July 7, 2017

Comment #26

Re: 303(d) List portion of the 2014 and 2016 California Integrated Report and/or 303(d) List for waterbodies in the Los Angeles Region

Figure 1: Excerpt figure from Draft Environmental Impact Report Ventura River Conjunctive Use Agreement. June 1978.

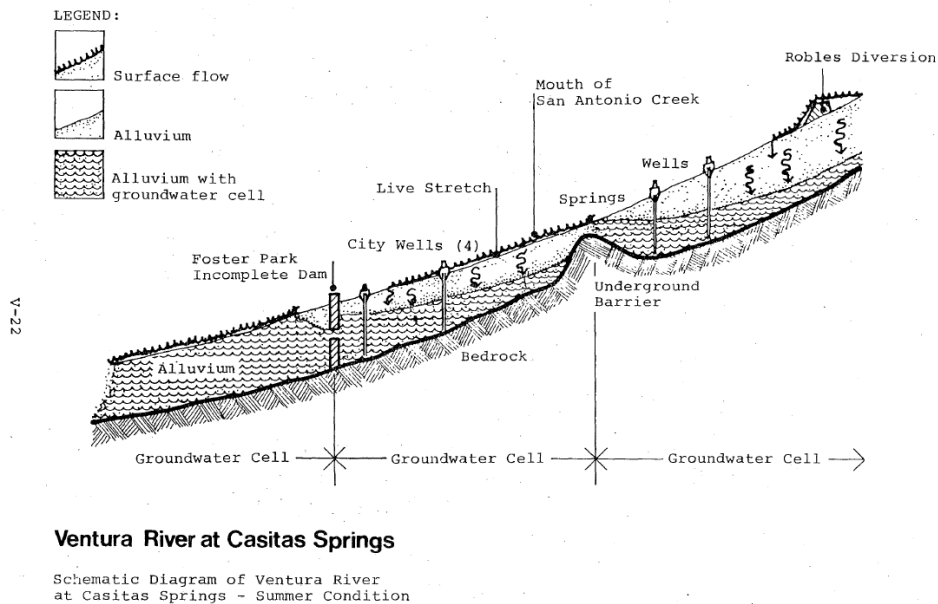
Draft EIR, p. V-22. Figure 1 below provides a diagram of the River’s surface flows, alluvium, and alluvium with ground water cells. *See also* Draft EIR, p. V-23 (providing an example of when and where the relationship between the groundwater and surface water occurs).

Figure 3. Monitoring sites, pumping and diversion facilities, and designated Reaches of the Ventura River

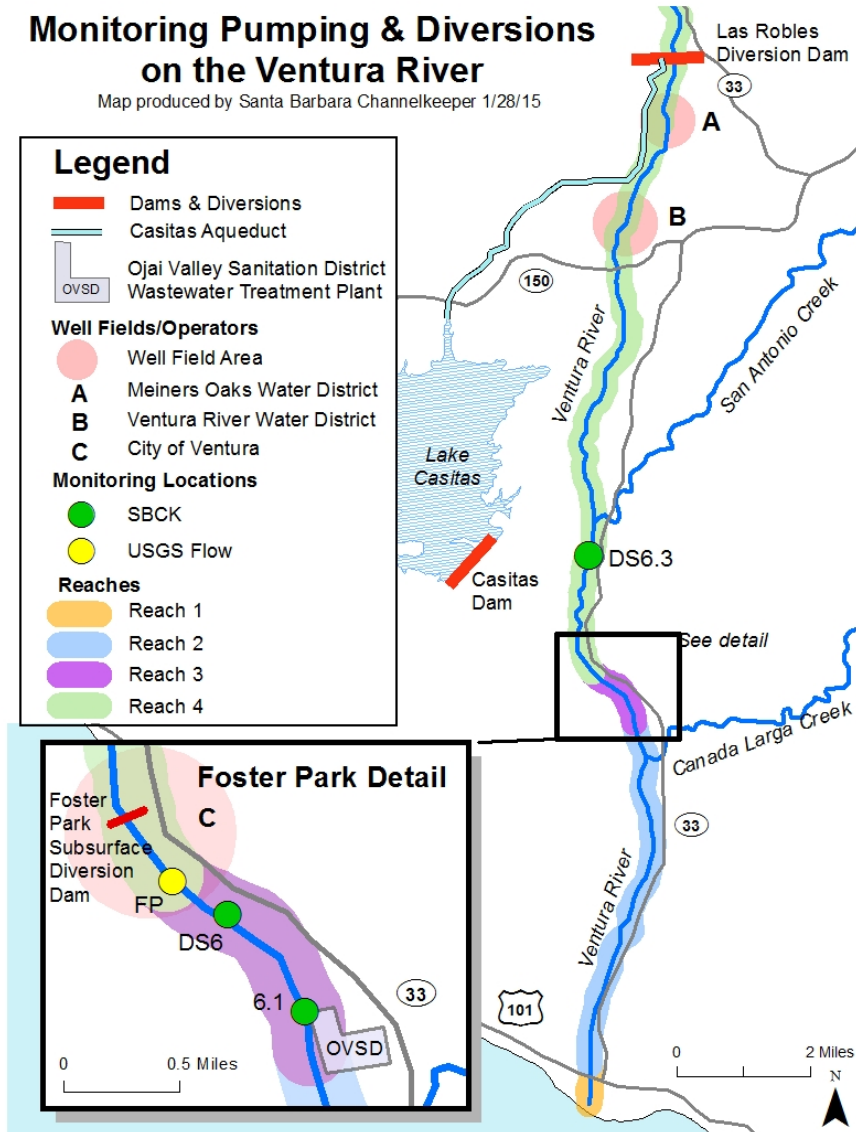
Data from monitoring stations maintained by Channelkeeper further demonstrate that recommended flow thresholds needed to protect beneficial uses have not been achieved in recent years. Figure 3 identifies SBCK monitoring site locations in relation to water diversion facilities and designated Reaches of the Ventura River, and Table 1 provides the flow data at Channelkeeper's monitoring sites.

Most of Reach 4 ran dry through 2013 and 2014 including at Foster Park. Some sections of Reach 4 are known to consistently run dry during the dry season. However, additional sections such as Foster Park characterized as perennial (Beller et al., 2011) also experienced total loss of surface flows in these years. Reach 3 (downstream of Foster Park) is the primary reach for which the recommended thresholds were developed. But as shown in Figure 3 and Table 1, measurements indicate that flow levels of 11 or 2 cfs were not observed at sites in Reach 3 (6.1 and DS6). Attachment B provides a summary of flow rates at the USGS Foster Park gage from 2007 through 2014. As demonstrated in Attachment B to Channelkeeper’s Line of Evidence and Table 1, Channelkeeper notes that flows have consistently fallen and remained below the recommended protective thresholds for many years.
